Grounding cable for electronic module of ROTAX Engine Series Type 912 A

Subject: Inspection of electronic module on engine series 912 A. Specifically, review cable lug connection onto grounding cable.

AIRWORTHINESS DIRECTIVE

No. 80

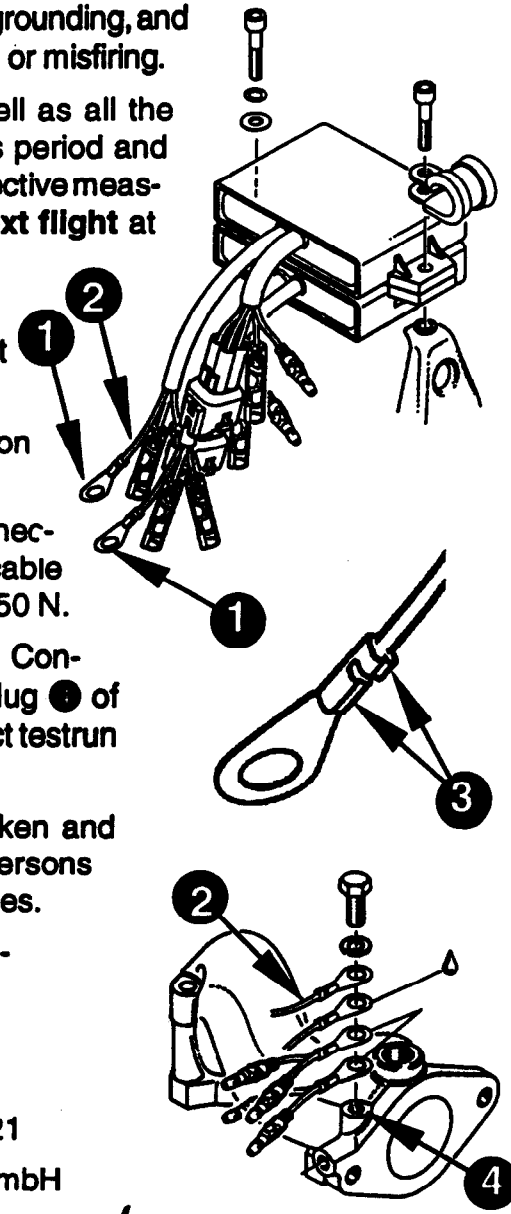
Reason: Production machinery problems may have caused inadequate cable assembly on electronic module, part no. 965 356.

In some cases the cable lug ❶ was not fitted tightly enough onto the grounding cable ❷, resulting in poor grounding, and possibly leading to engine stoppage or misfiring.

Remedy: To guarantee the sufficient crimping ❸ of the cable lug a pull-off test with 50 N has to be conducted.

At occurrence of an inadequate connection, correct by crimping on new cable lug, part no. 964 056 and test with 50 N.

Apply Lithium grease on cable lug. Connect both grounding cables ❷ on lug ❸ of the right intake manifold and conduct testrun and ignition check.

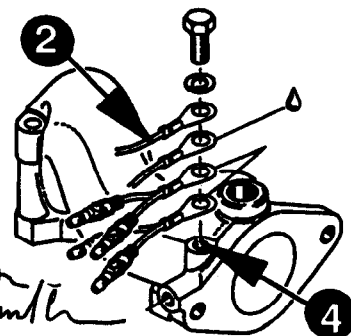
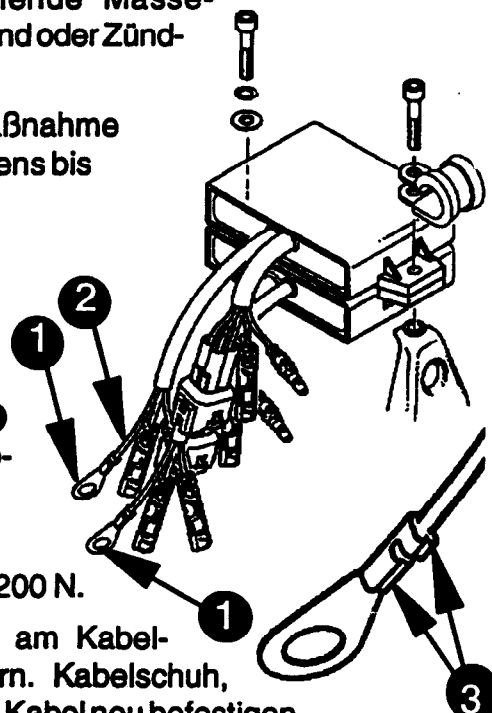
Anlaß: Probleme an der Fertigungsmaschine könnten eine nicht korrekte Herstellung des Kabelbaumes für das Elektronikmodul, Teile-Nr. 965 356 verursacht haben.

In einigen Fällen war der Kabelschuh ❶ nicht ausreichend auf das Massekabel ❷ aufgepreßt. Die unzureichende Masseverbindung könnte ungewollt Motorstillstand oder Zündaussetzer bewirken.

Abhilfe: Um sicherzustellen, ob die Krimpung ❸ des Kabelschuhes ausreicht, ist ein Abziehversuch mit 50 N durchzuführen.

Sollte eine unzureichende Verbindung am Kabelschuh vorliegen, ist dieser zu erneuern. Kabelschuh, Teile-Nr. 964 056 mit der Krimpzange am Kabel neu befestigen und einen 50 N Abziehversuch durchführen.

Kabelschuhe mit Lithium Seifenfett einstreichen. Beide Masseleitungen ❹ am Butzen ❺ des rechten Ansaugstutzens befestigen und einen Motorprüflauf mit Magnetcheck durchführen.
